Petroleum Refineries: Catalytic Cracking Units, Catalytic Reforming Units, and Sulfur Recovery Units - Background Information for Promulgated Standards and Response to Comments

Final Report

EPA-453/R-01-011

June 2001

Figure 1. Available Ni Emission Test Data for FCCUs in lbs Ni/1000 lb coke burn

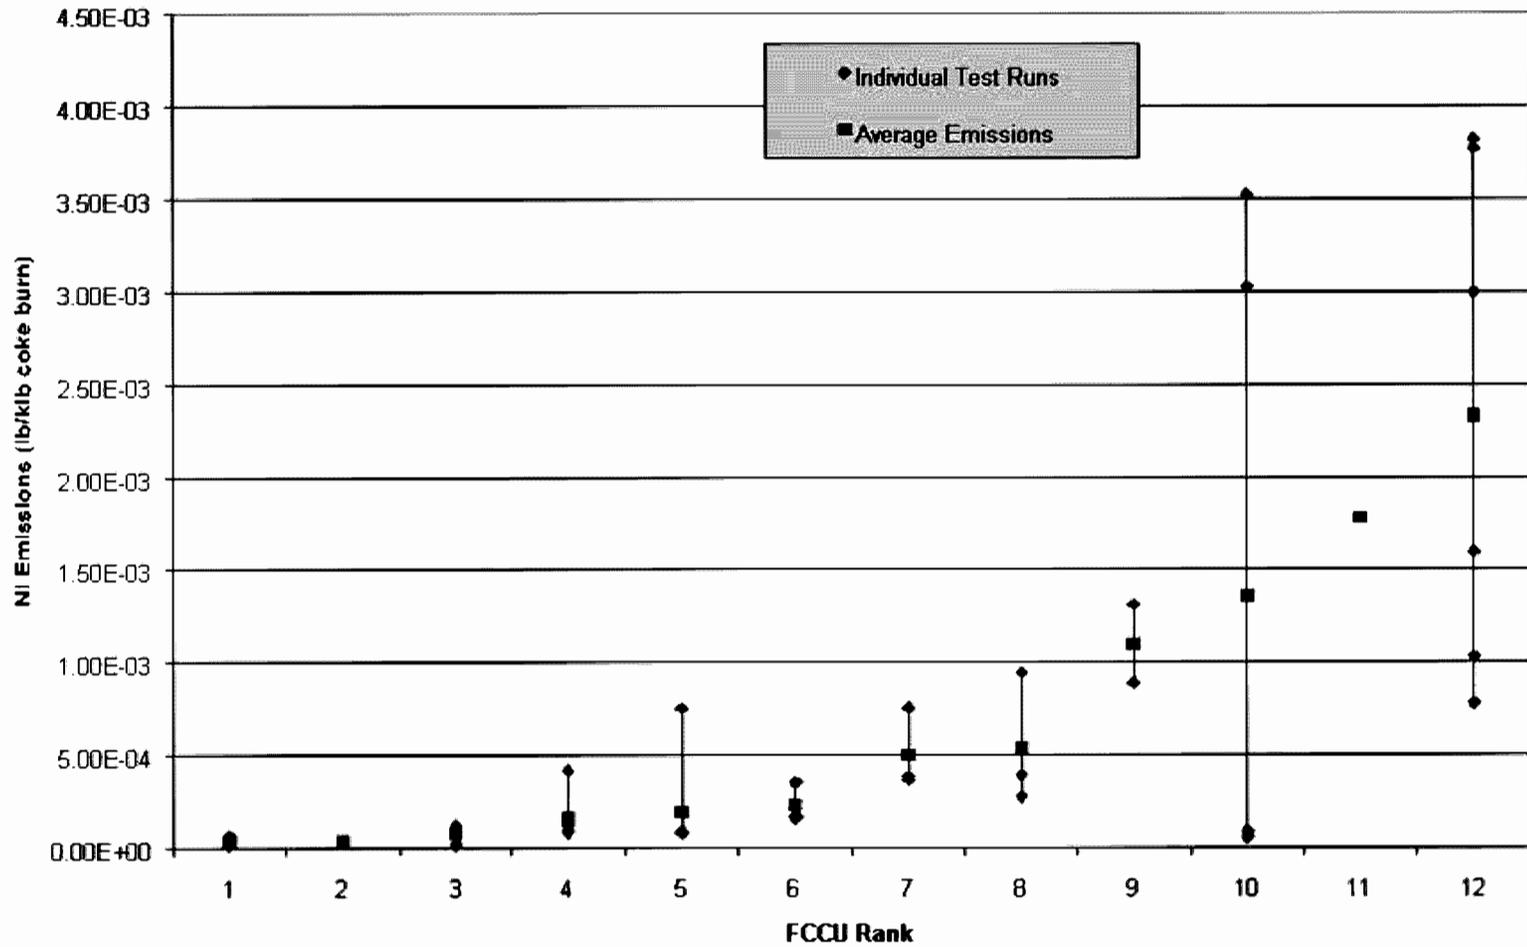
Comment: According to Commenters IV-D-30 and IV-D-31, the relationship between PM emissions and Ni (or any other metal IIAP) is best characterized by material balance equations which should be used instead of the statistical measures under consideration. Industry commenters generally contend that the highest value must be used. Commenter IV-D-48 contends that since all sources must be able to achieve a standard, EPA must choose the highest value of Ni as the representative concentrations used in the conversion from PM to Ni. The choice of the 90th percentile, the arithmetic mean, or the geometric mean would automatically exclude sources that have higher Ni concentrations from meeting any standard based on those levels without controlling their PM emissions to a lower level than the control technology of choice would allow. This would force those refiners to choose the PM standard instead of the Ni standard.

Response: As noted previously in comment/response 1.8, the EPA has decided to include an additional metal IIAP alternative for FCCU formatted in terms of lbs of Ni emissions per 1,000 lbs of coke burn. It has been concluded that this particular format (i.e., lb Ni/ 1,000 lbs coke burn) accounts for the wide variation of processing capacity within the industry and provides adequate means of determining continuous compliance. However, it also has been concluded that the approach of using E-Cat Ni concentration data to make a direct conversion of the PM emission standard to a Ni limit is not the appropriate methodology to establish the emission limit in this format. The conversion factor approach is not technically equivalent nor does it relate to performance of the MACT floor technology. No rationale has been established that would support the determination or derivation of the second alternative Ni emission limit value based on using the PM emission limit that reflects the performance of the MACT control technology and the Ni concentration in the CCU catalyst fines to convert the PM mass to an equivalent Ni mass. Use of the Ni fines (or E-Cat) concentration at any value (highest, lowest, mean, or 90th percentile) as a conversion factor would not result in an emission limit that is technically equivalent to the MACT floor since the E-Cat Ni concentration does not reflect the performance of the MACT floor technology, as does PM emissions. The Ni E-Cat concentration of a FCCU are dependent on a complex mixture of operating and economic considerations.

The Agency has no data or information to relate E-Cat metals concentration to the best performing facilities (i.e., E-Cat metal concentration does not reflect or relate to control device performance).

The EPA has concluded that use of the worst case Ni E-Cat in a direct conversion of the PM limit to a Ni limit is in no way reflective of or linked to Ni emission control or the MACT floor technology. The EPA analysis indicates that an alternative standard based on the highest Ni E-Cat concentration to convert PM to Ni would require at most two facilities to add controls; the industry analysis shows the number of facilities adding controls dropping from 45 to six facilities. In addition, a standard at this high level could in the long term result in increased emissions of metal IIAP rather than their control given the general trend in the industry to process lower quality crudes.

We have therefore developed a Ni emission limit in the particular format (lbs Ni/1,000 coke burn) that characterizes the performance of the MACT floor technology. The emission limit was determined based on the available emissions test data normalized in terms of coke burn rate using an analysis following basic EPA criteria for determination of the MACT floor. See comment/response 1.8 for more information on the alternative emission limit formatted in lb Ni per 1,000 lbs of coke burn.
